**Project #18-037
Gossner Grade A Warehouse
Located at 1105 North 1000 West**

Project Name: Gossner Grade A Warehouse
Proponent/Owner: Travis Johnson / Gossner Grade A Warehouse
Project Address: 1105 North 1000 West
Request: Design Review Permit
Current Zoning: Industrial (IP)
Date of Hearing: October 25, 2018
Type of Action: Quasi-Judicial
Submitted By: Russ Holley, Senior Planner

Staff recommends that the Planning Commission conditionally approve a Design Review Permit for Project #18-037 Gossner Grade A Warehouse, for a 70,000 SF industrial building located at approximately 1105 North 1000 West, TIN# 05-050-0002; -0007.

AS101

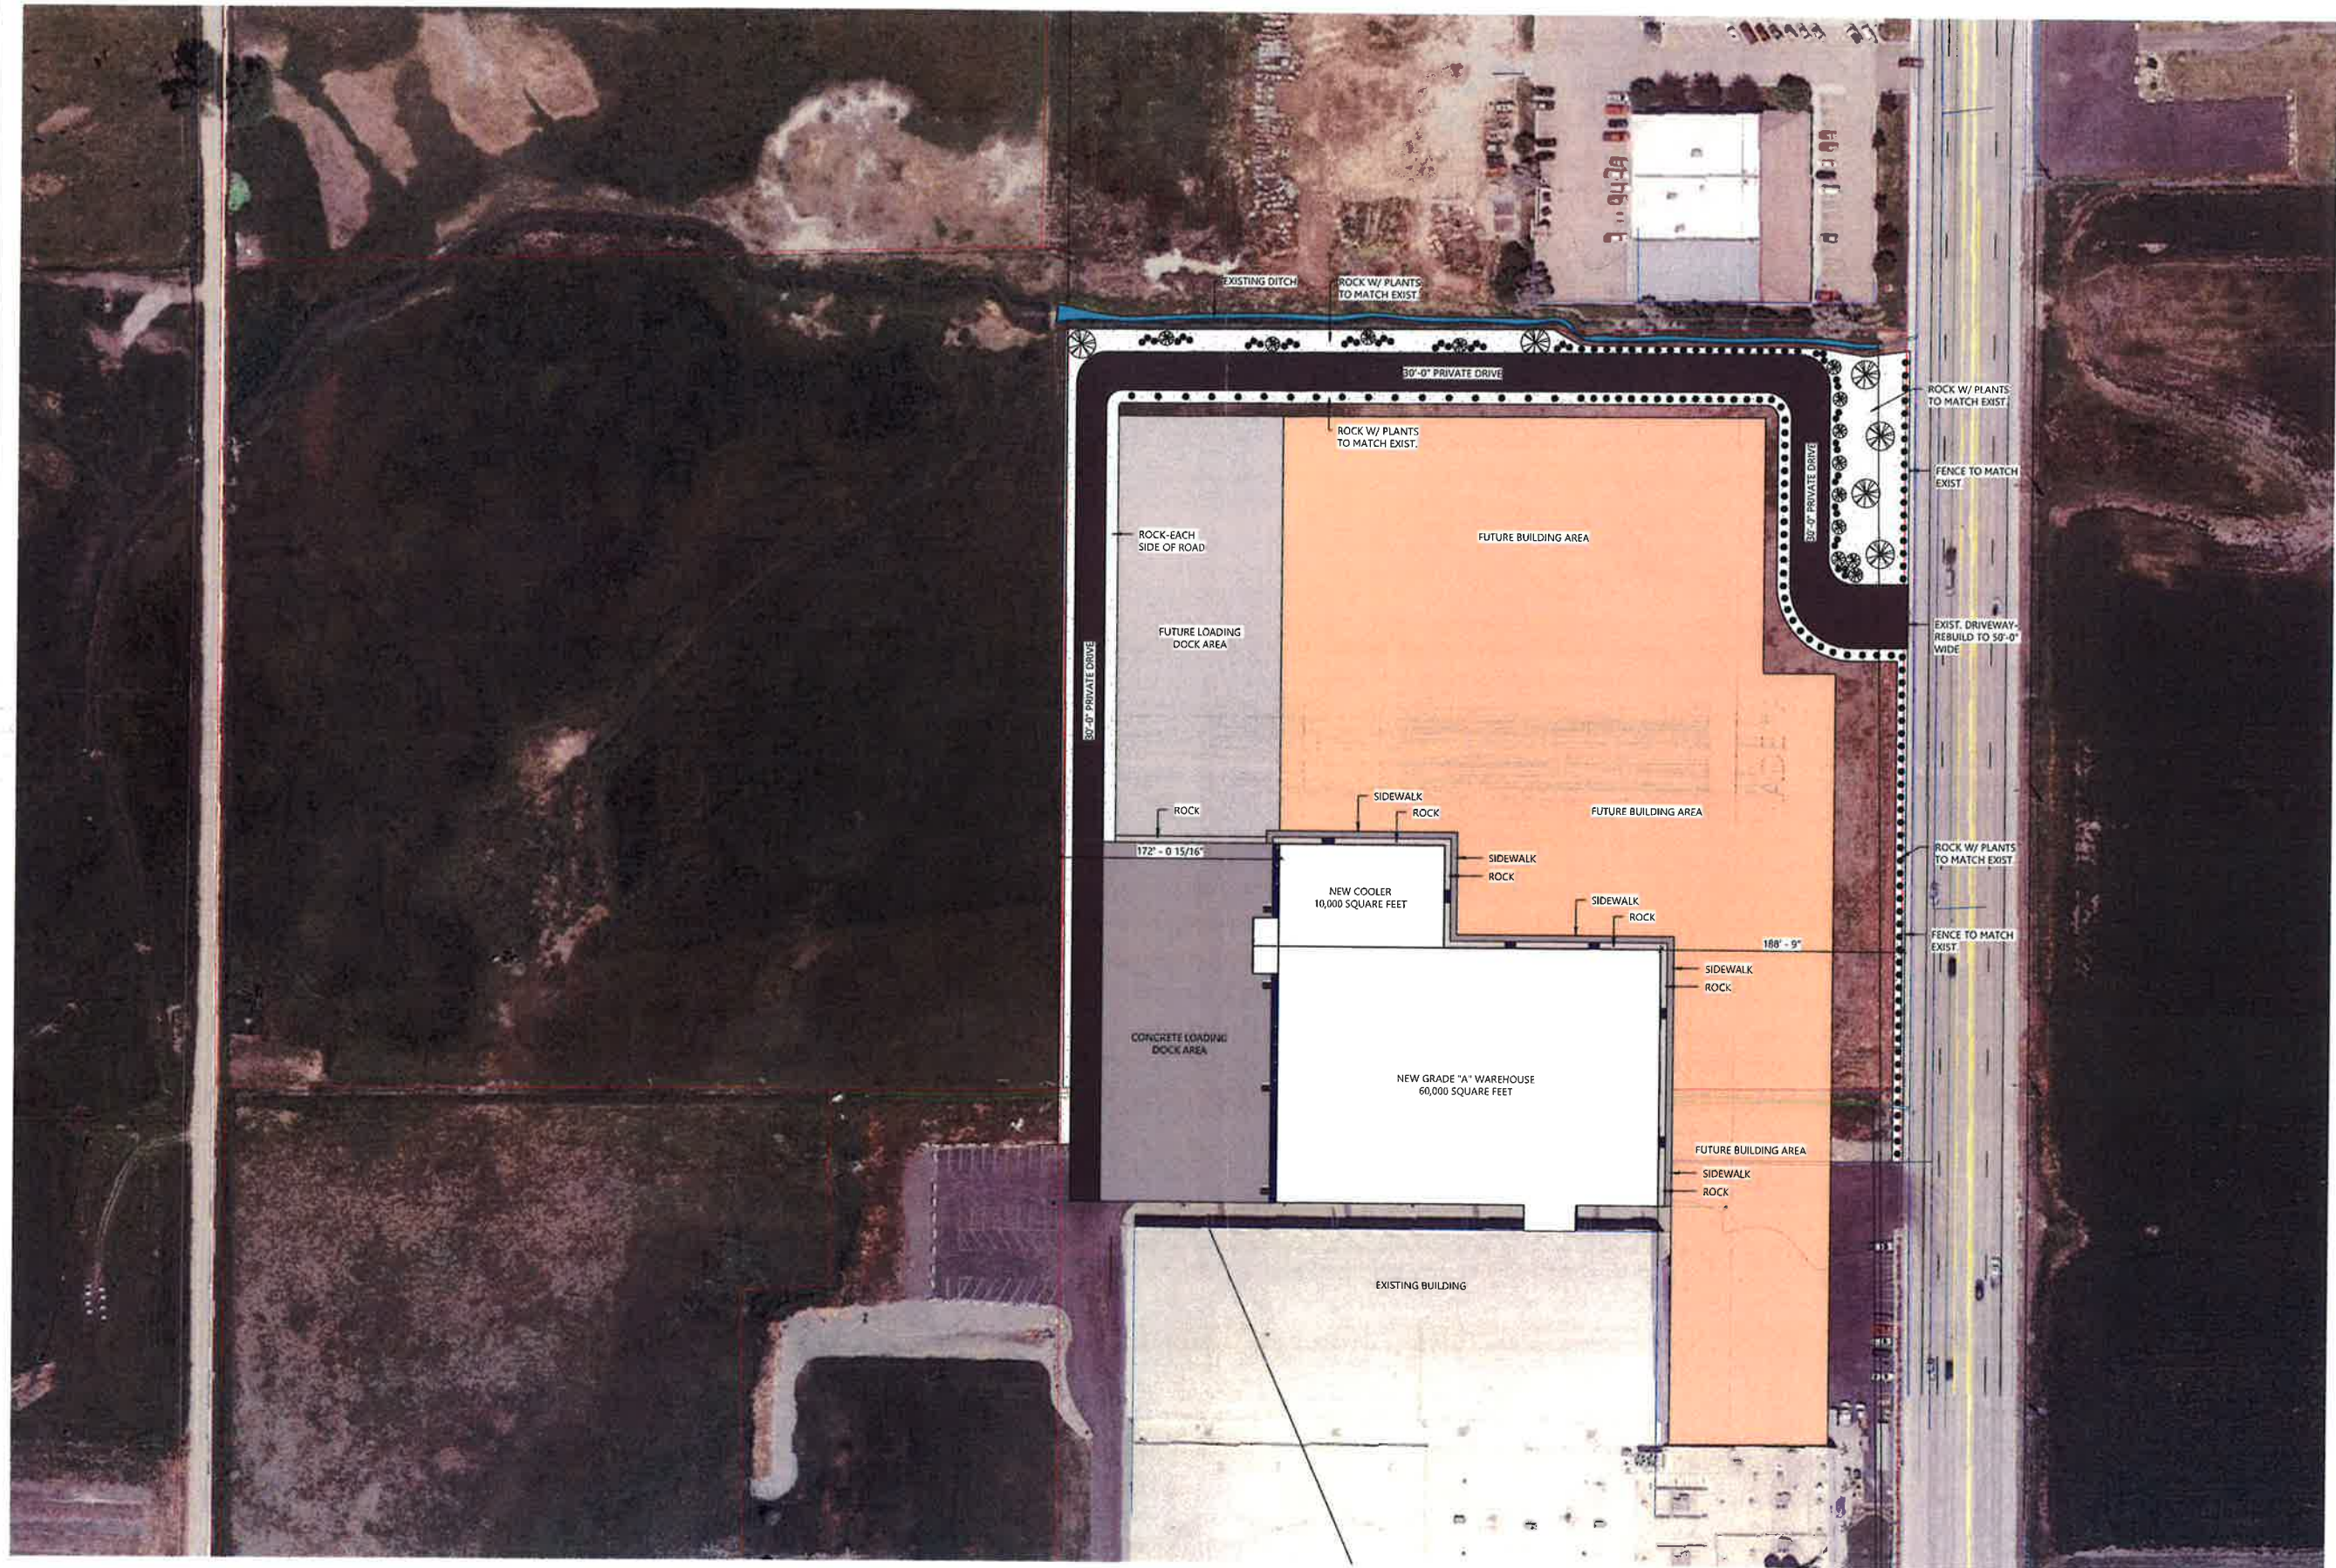
The LDC 17.30.160 requires pedestrian circulation within a project and connecting to adjacent public streets. Pedestrian circulation should provide a safe, convenient and well-connected sidewalk network. The proposed project does not show sidewalk connections. As conditioned with sidewalk connections, the project meets the requirements in the LDC.

The LDC 17.31.040 requires one (1) parking stall per every 2000 SF of warehouse space. The proposed building has approximately 60,000 SF of warehouse space. This building would require 30 parking stalls. The proposal does not define parking stalls on-site. As conditioned with a minimum of 30 parking stalls, the project meets the parking requirements in the LDC.

- Plans indicate a future access road a significant distance to north of the proposed new building. Fire access roads in buildings with high piled storage shall be within 150 ft of portions of the exterior of the building. Access roads shall be 20 ft. wide. Dead ends longer than 150 ft. shall be provided with a turn-around. Will a temp. access road be provided until the property is build out? Provide AutoCAD two track drawing indicating the following apparatus specifications on all fire access road and lanes: Inside turn 17 ft., Curb to Curb 32ft., and Wall to wall 36 ft.

6. Pedestrian sidewalks shall be provided that connect building(s) to adjacent streets for overall pedestrian circulation.
7. A performance landscaping plan, prepared in accordance with §17.32 of the LDC, shall be submitted for approval to the Community Development Department prior to the issuance of the building permit. The plan shall include the following:

- Fire Sprinklers and Alarms Required. Fire hydrant within 100 ft of FDC required.
- Access
- (IFC 503.1.1) Fire Apparatus Access shall extend to within 150 feet of all portions of the facility as measured by an approved route around the exterior of the building.
